Presentation #2 – Site + Building Form

RiverHouse

Rezoning (REZN22-00007)

Phased Development Site Plan (SPLN23-00001)

C1 Building: West Façade

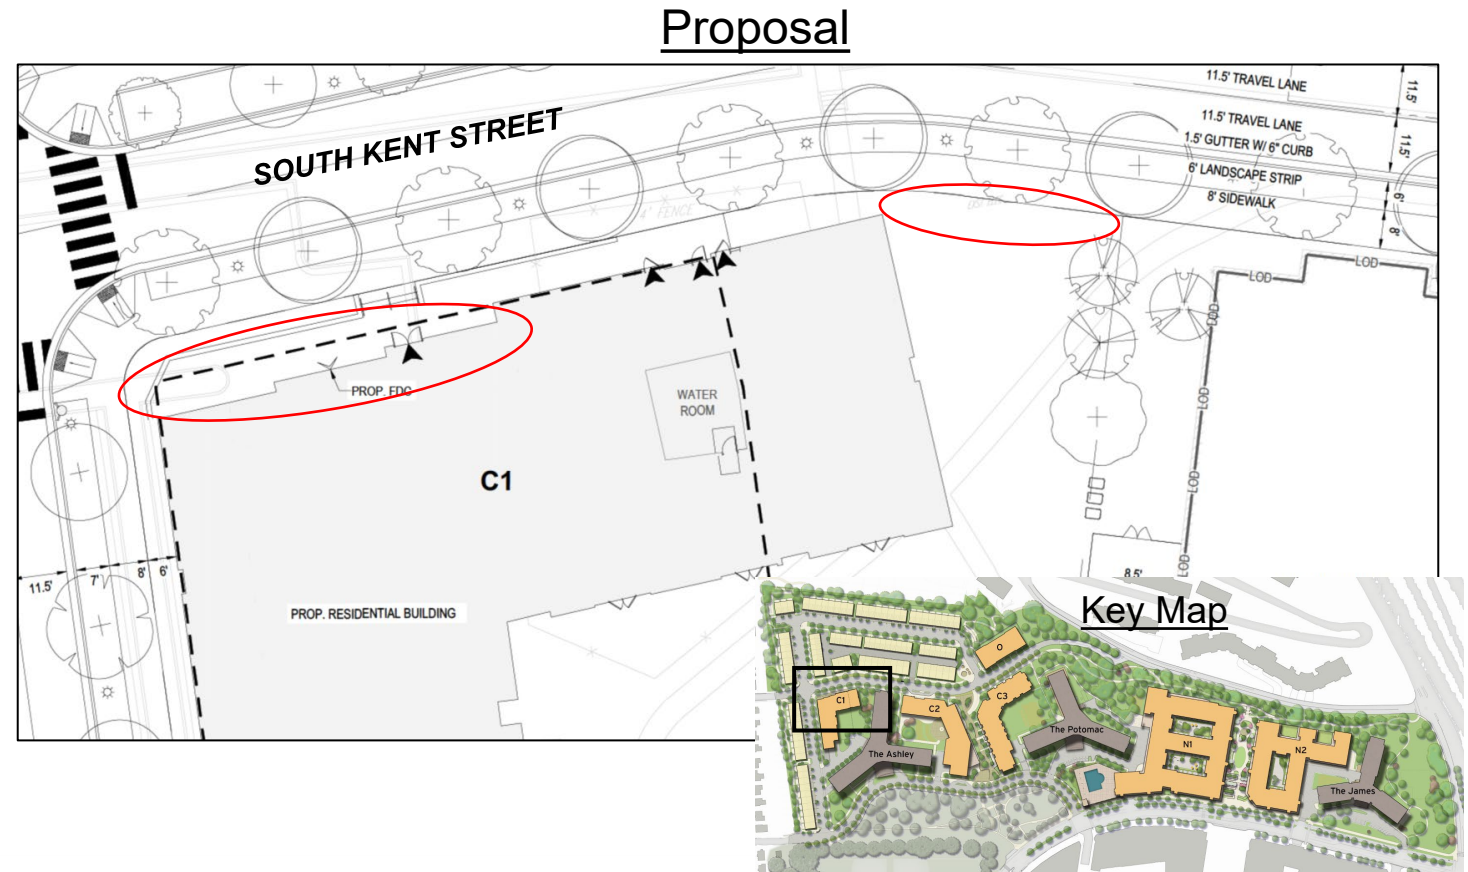
Building edge does not engage Kent Street sidewalk

- Western building edge doesn't meet frontage requirement

- Building edge present within the (8-ft.) build-to zone for at least 55% of the parcel edge
